CENTRAL WATERFRONT
DOGPATCH
PUBLIC REALM
PLAN

LAND USE SCENARIOS

WORKSHOP #3

DATE: FEB 8 2017
LOCATION: POTRERO HILL REC CENTER

SCENARIO 3: MEADOWS EQUAL IN SIZE, DOG PLAY AREA IN NORTH MEADOW

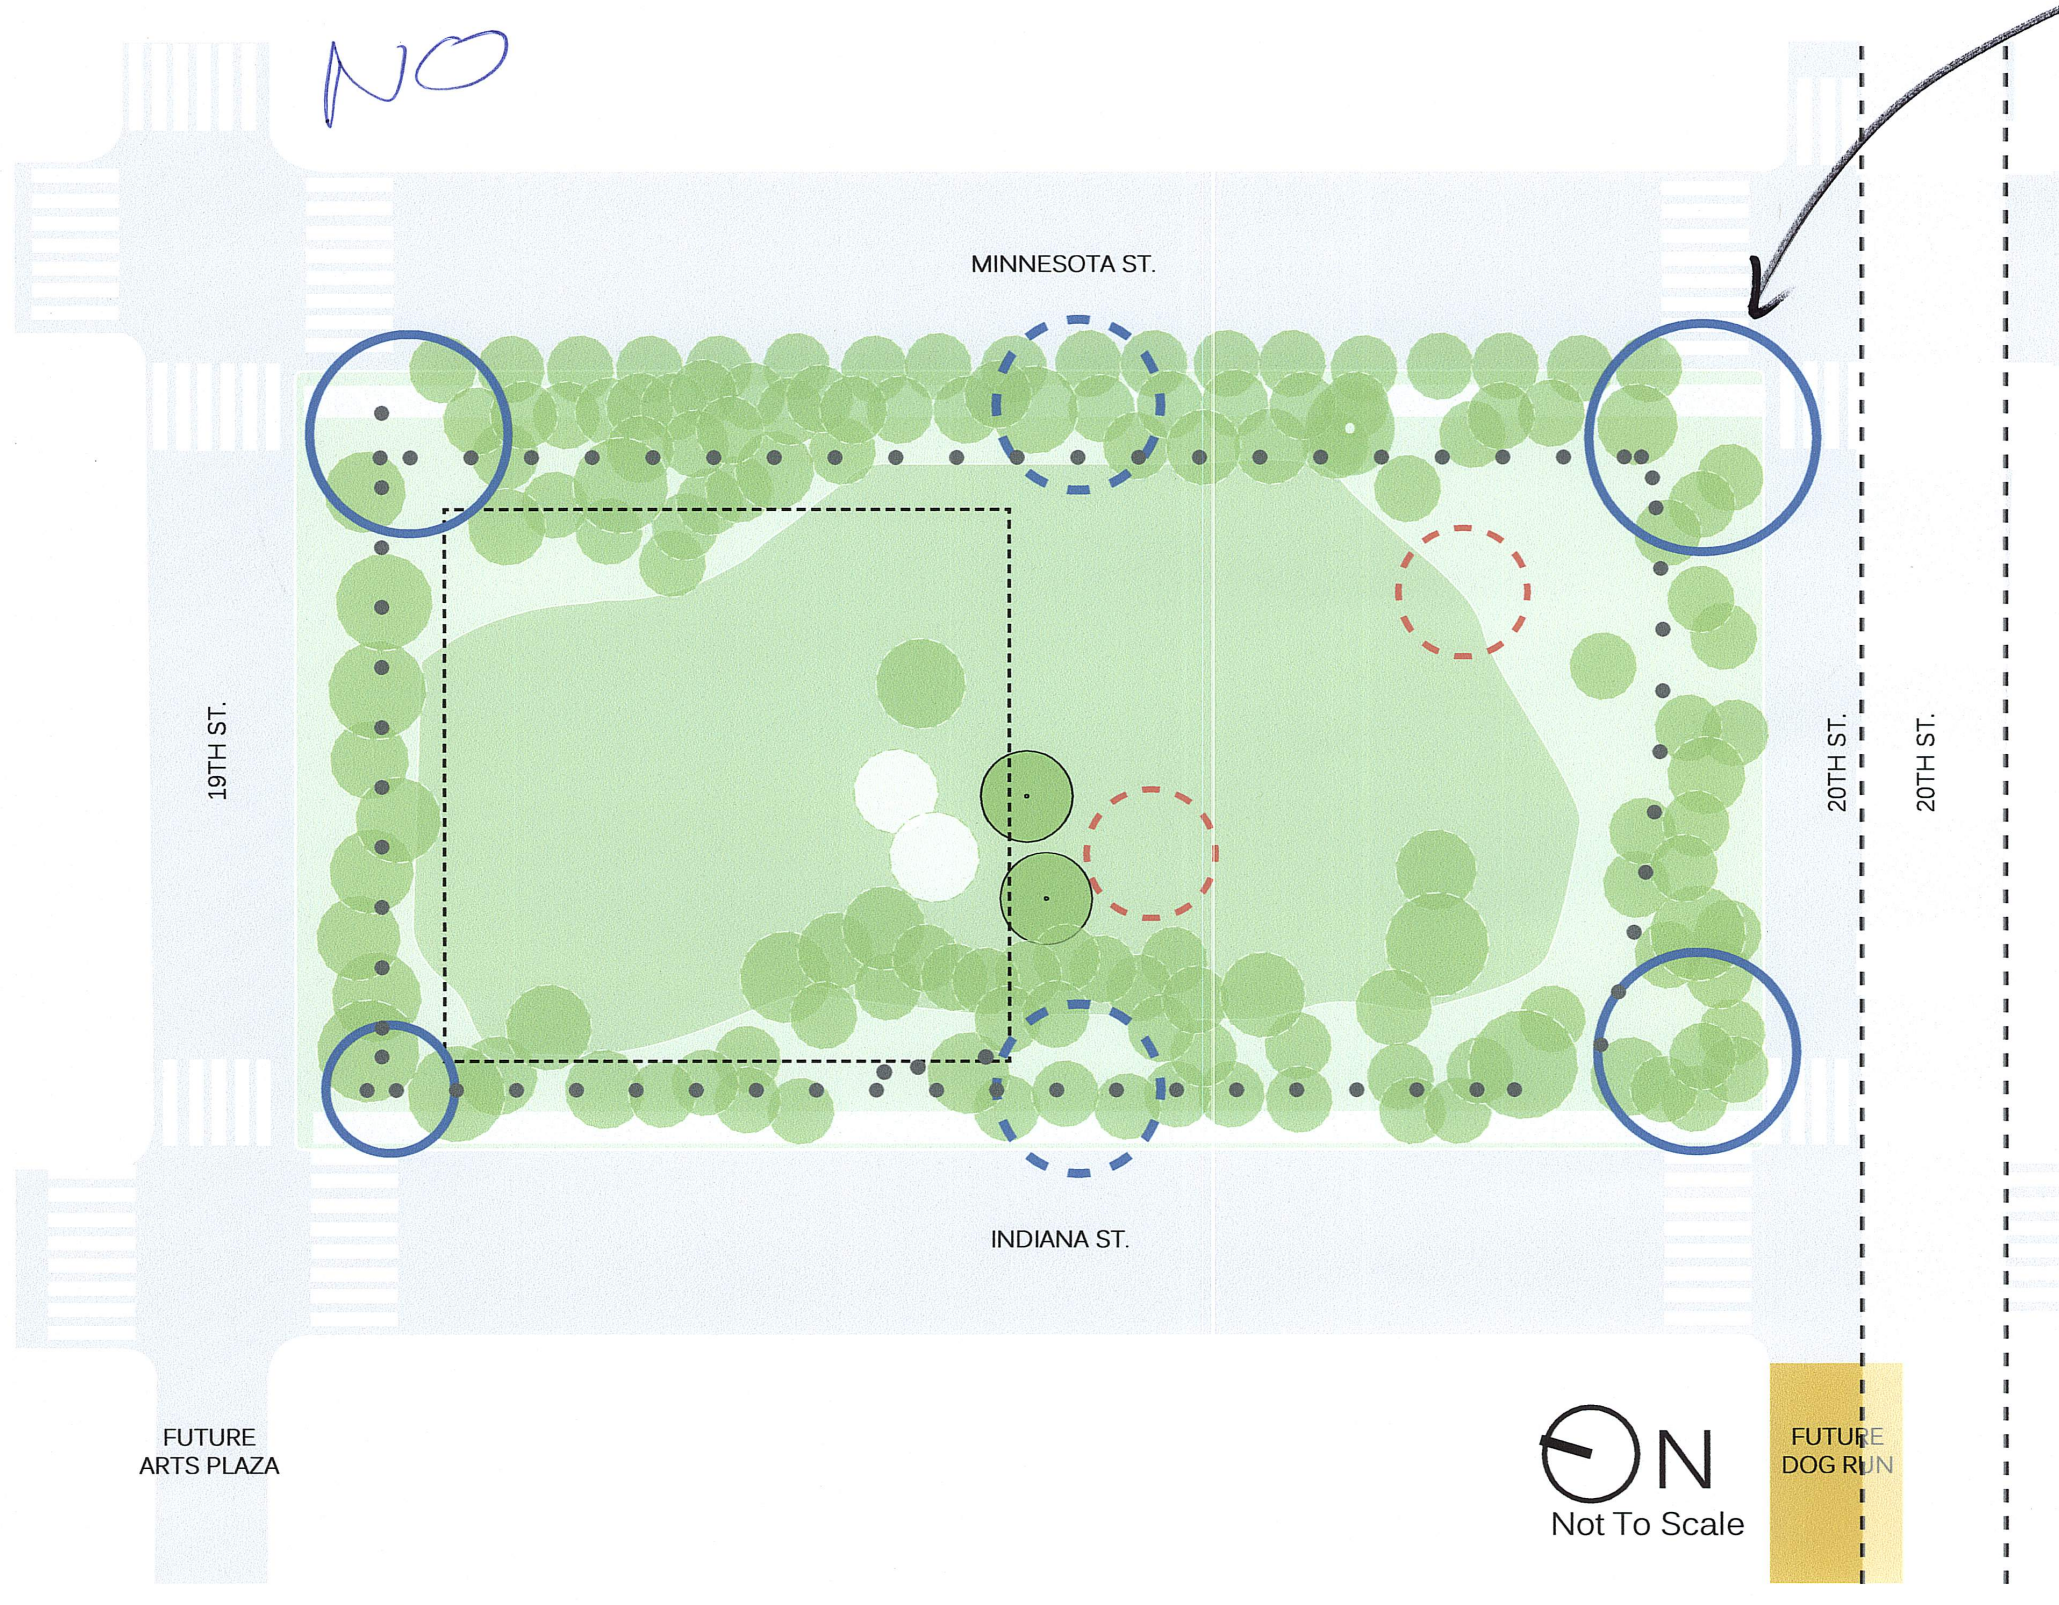
NO

LIKE ENTRIES; THIS DRAWS PEDS INTO PARK- GOOD.

COMMENTS: This is not the right side for dogs, the traffic is on 19th st the 20th st side is best due to slow traffic where dogs can run out.

the south meadow should remain the same size ④

LIKE THIS OPTION.

SCENARIO 4: MEADOWS EQUAL IN SIZE, DOG PLAY AREA IN SOUTH MEADOW

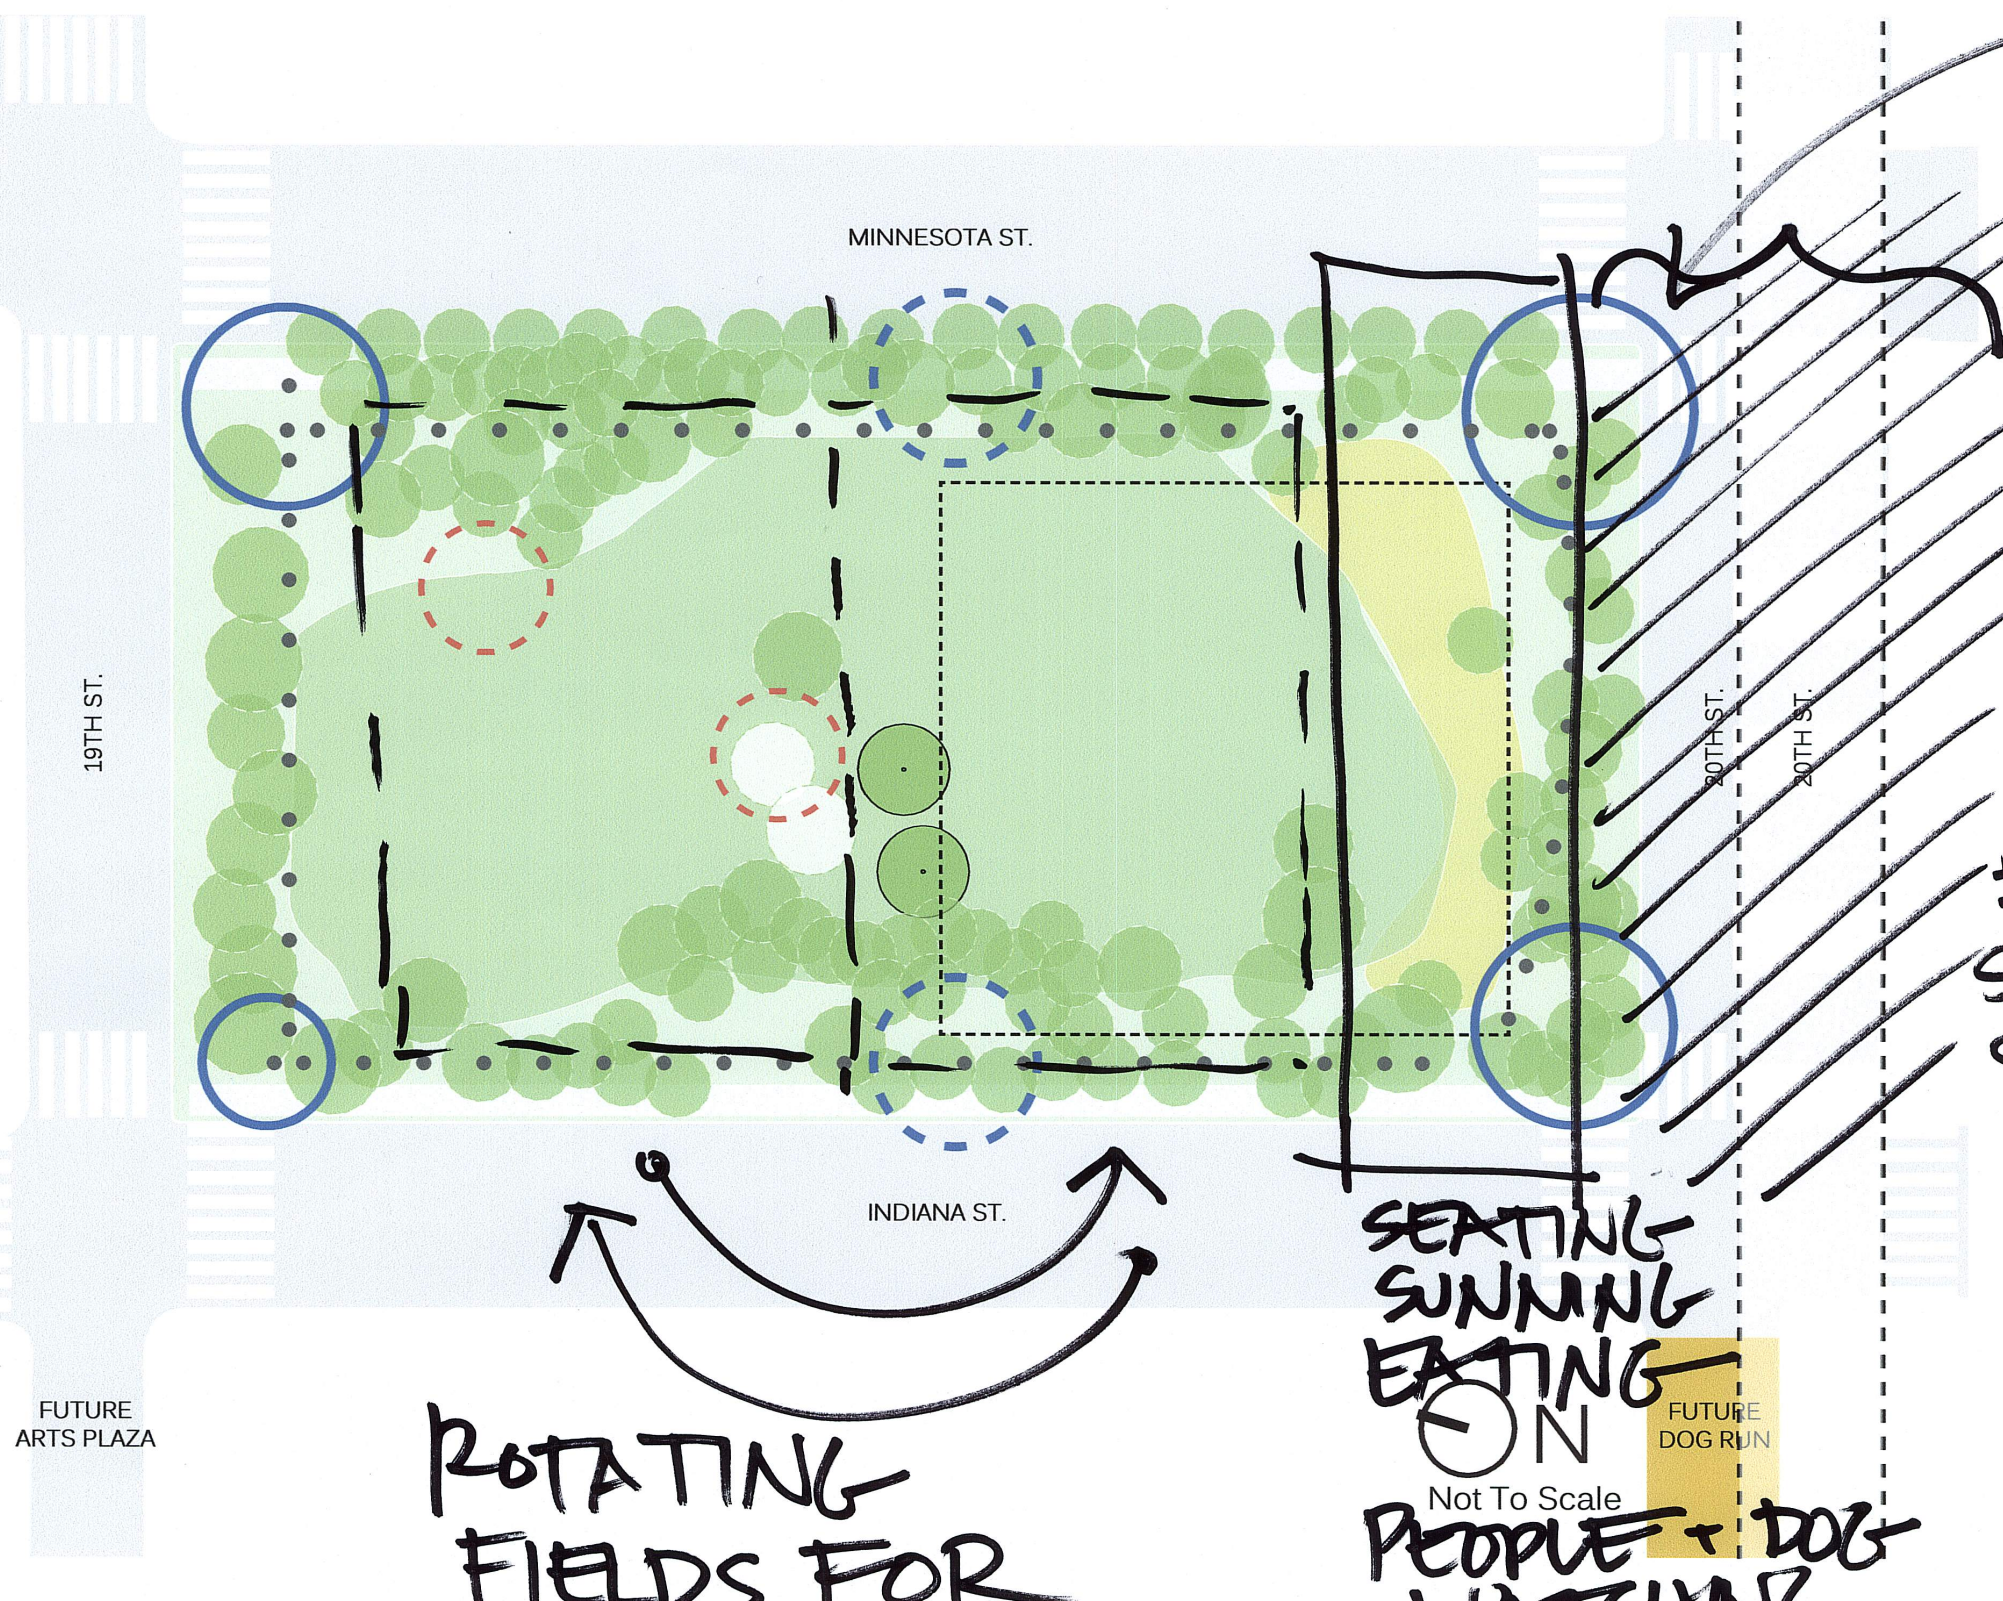
LIKE ENTRIES; THIS DRAWS PEDS INTO PARK. GOOD IDEA.

FUTURE SHARED STREET.

SEATING SUNNING EATING

PEOPLE + DOG WATCHING

ROTATING FIELDS FOR TURF REGROWTH ☺

COMMENTS: The current size gets dogs proper exercise, this is abit too small not enough room for dogs ④ the park doesn't need to have the space so be engineered

NO - south is sunnier + should be for people

yes. South side for people, who may or may not have dogs People play baseball + frisbee, w/ people &/or w/ dogs

↑ FACT

LIKE THIS OPTION.
